HISTORIC AND DESIGN REVIEW COMMISSION

HDRC CASE NO: 2022-539
COMMON NAME: 1818 and 1822 Martin Luther King
ADDRESS: 1824 MARTIN LUTHER KING DR
LEGAL DESCRIPTION: NCB: 1532 BLK: 13 LOTS: 6 7 & 8
ZONING: RM-4, H
CITY COUNCIL DIST.: 2
APPLICANT: Jenny Hernandez/HERNANDEZ JENNY & HERNANDEZ ANDREW
OWNER: Jenny Hernandez/HERNANDEZ JENNY & HERNANDEZ ANDREW
TYPE OF WORK: New construction of a 2-story duplex structure
APPLICATION RECEIVED: October 25, 2022
60-DAY REVIEW: Not applicable due to City Council Emergency Orders
CASE MANAGER: Claudia Espinosa

REQUEST:

The applicant is requesting a Certificate of Appropriateness for approval to construct two, multi-family residential structures on the vacant lots at 1818 and 1822 Martin Luther King Drive.

site plan

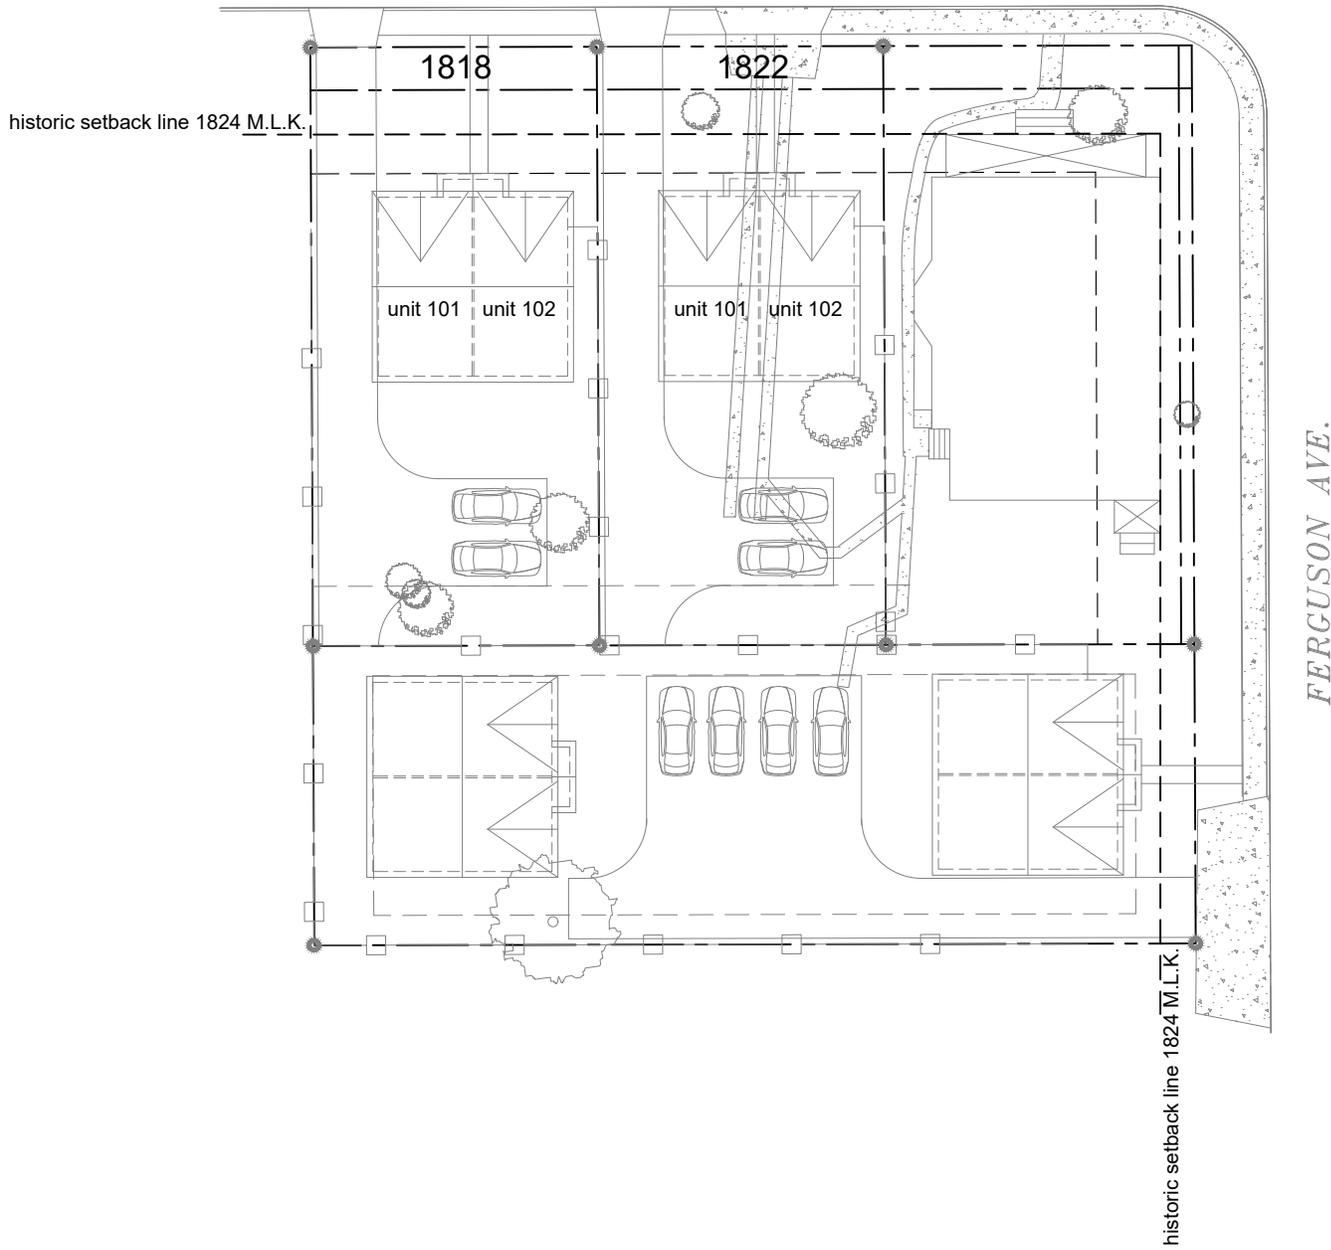
- b. SETBACKS & ORIENTATION (MARTIN LUTHER KING DR.) – According to the Guidelines for New Construction, the front facades of new buildings should align with the front facades of adjacent buildings where a consistent setback has been established along the street frontage. Additionally, the orientation of new construction should be consistent with the historic examples found on the block. The applicant has indicated that the structures will be set back from the front property line by ten (10) feet and that both structures will feature a greater setback than the adjacent historic structure. Staff finds the proposed setback to be appropriate and consistent with the Guidelines.

- h. LOT COVERAGE – Per the Guidelines for New Construction, the building footprint for new construction should be no more than fifty (50) percent of the size of the total lot area. Staff finds the proposal consistent with the Guidelines, per the submitted site plan.

- p. LANDSCAPING PLAN – The applicant has provided landscaping information on the site plan noting the installation of grass throughout the front and rear yards of each site, as well as the location of existing trees. Generally, staff finds the proposed landscaping to be appropriate and consistent with the Guidelines.
